RE: Levy County Nuclear Power Plant Discharge into Existing Florida Barge Canal

PROJECT: FLORIDA BARGE CANAL COOLING BASIN
LEVY COUNTY, FL

TITLE: CONCEPTUAL LAYOUT

CONCEPTUAL COOLING BASIN PLAN
NO SCALE

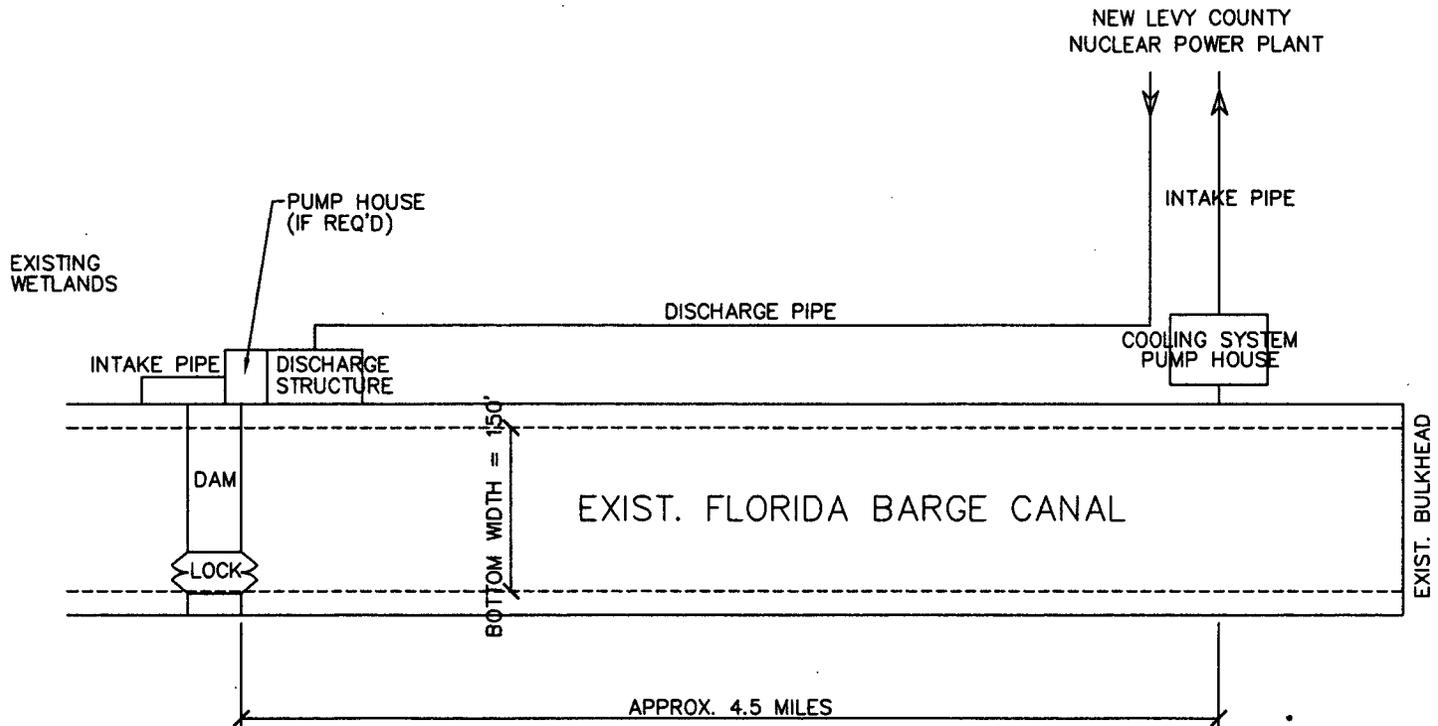
This brings me to the purpose of this letter. This letter is a engineering proposal that is being submitted that should be consider for discharging the nuclear power plant cooling water at a point where the proposed discharge pipe was going to cross the canal. Additionally, next to discharge location, a earth or concrete dam with a lock system would need to be provided on the west side of this discharge outlet. This would create a close system for recycling the cooling water for the new

I have run some preliminary calculations, to determine the estimated cycle time of the water contained in the new formed cooling basin. See Attachment #1 to this letter for a proposed layout of the infrastructure needed as outlined in this letter. The numbers are as follows to determine the estimated recycle time:

With a bottom width of the existing canal at 150 feet and an estimated depth of 12 feet, the average cross section of the existing barge canal is determined to be approximately 2,000 square feet. The separation point between the intake structure and discharge outlet and dam structure would be approximately 4.5 miles long. This creates a volume of stored water of approximately 47.5 billion cubic feet contained within this basin. It is my understanding that the daily flow for use in cooling this nuclear facility is to be 1.85 million gallons per day (247,300 cubic feet). If this is the case, the cycle time for recycling water within this basin would be a total of 192 days. Hopefully, a time period long enough to sufficiently cool the 95 degree discharge water?

Another benefit the basin could also provided if it is used as a manatee sanctuary area during the winter months since a lock at the dam enable passage to the cooling basin where the water is warmer during winter months. The lock could be open occasionally and be used as a staging area to allow the mammals to enter the basin. The lock could also be used for any barge traffic which needed to enter the basin for the nuclear power plant or other purposes. It also would allow water to be added to the basin if the level became low. I also have shown a pump station as an option rather than using a lock for this purpose.

Another benefit would be the reduction of 2.5 miles of discharge piping along side the Gulf of Mexico. With less piping, the pumping system for the discharge system would need less horsepower therefore providing additional construction cost savings. Also, I believe wetlands presently exist between the existing barge canal and the Crystal River Nuclear Power Plant. By
